MACARTHUR TRANSIT VILLAGE PROJECT

Volume 4. Response to Comments Document
SCH No. 2006022075

Prepared for:
City of Oakland

NOTICE OF AVAILABILITY OF FINAL ENVIRONMENTAL IMPACT REPORT FOR THE MACARTHUR TRANSIT VILLAGE DEVELOPMENT PROJECT

Figure 1: Modeled annual average concentrations of PM 2.5 from freeway sources at the Macarthur Transit Village

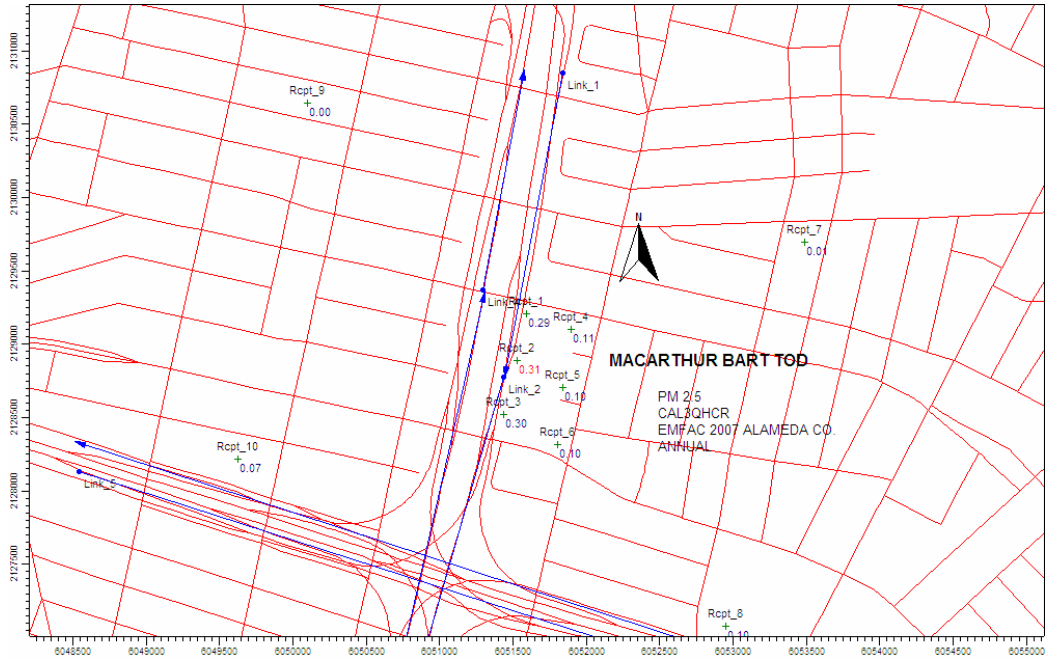
Figure 1 (attached below) illustrates estimated annual average freeway contributions to PM 2.5 concentrations at the Mac Arthur Bart Transit Village project site. Based upon the CAL3QHCR Line Source Dispersion Model Version 2.0, the maximum annual average contribution to PM 2.5 concentrations of from vehicles on major roadways at the project site was 0.31 micrograms per cubic meter. Figure 2 reflects the highest 24 hour concentration from freeway sources.

There is no established health based no effect level for PM 2.5 exposure and both EPA and CARB have acknowledged that health effects occur below current state and federal thresholds for PM. Based upon recent study in Los Angeles, a 0.1 ug /m3 change in PM2.5 results in a 0.14% increase in non-injury mortality or an increase of about one excess death per 100,000 persons per year (Jerrett 2005). Similarly, based upon Concentration Response Functions in the 2002 CARB Staff Report on AAQS for PM a 0.1 ug /m3 increase in PM2.5 affecting a population of 100,000 adults would result in about 1 extra premature death per year. The same increase would result in ~80 days per year with respiratory symptoms, 108 days with work limitations, and 577 days with minor activity limitations in the same adult population.

FIGURE IV.K-1

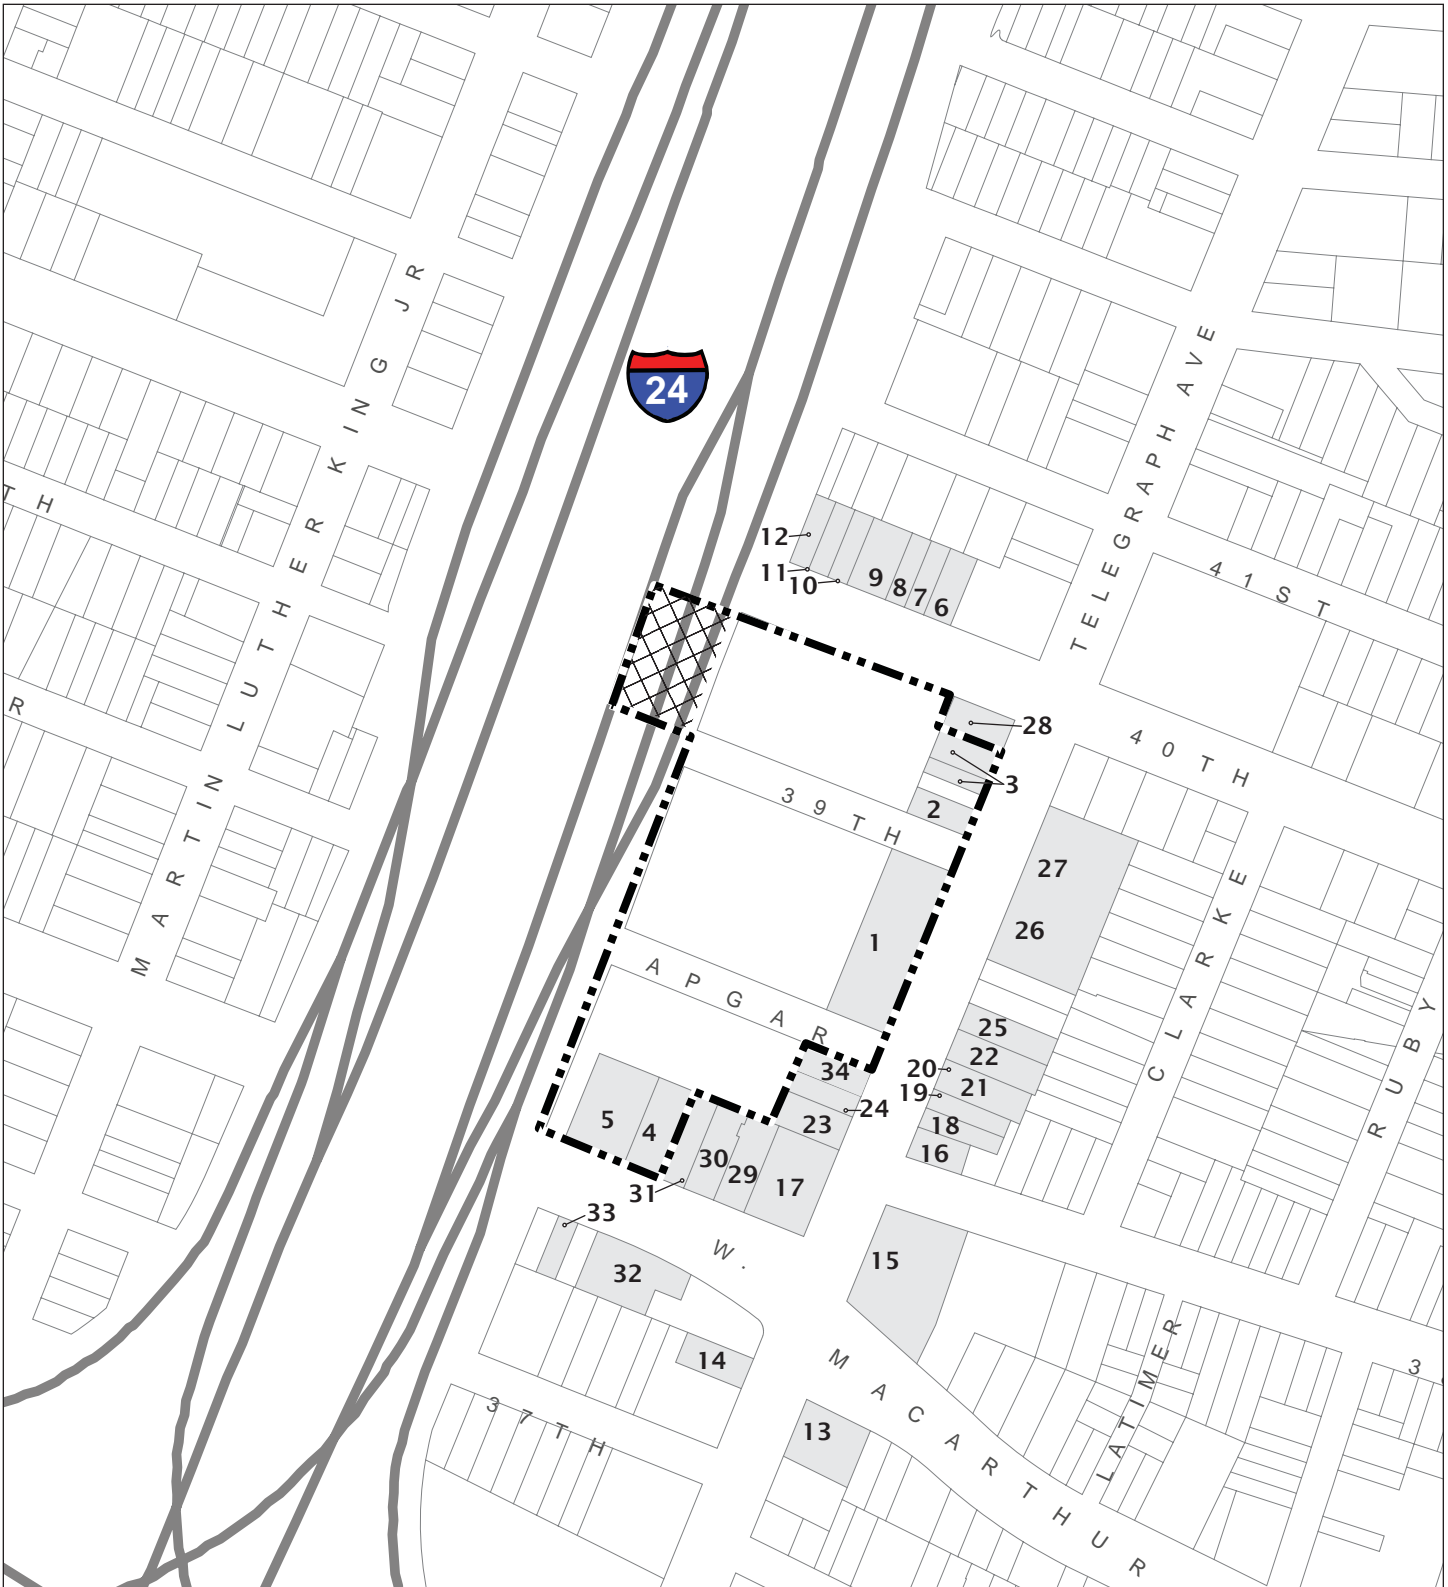
Page 411, Figure IV.K-1, has been revised as shown on the following page:
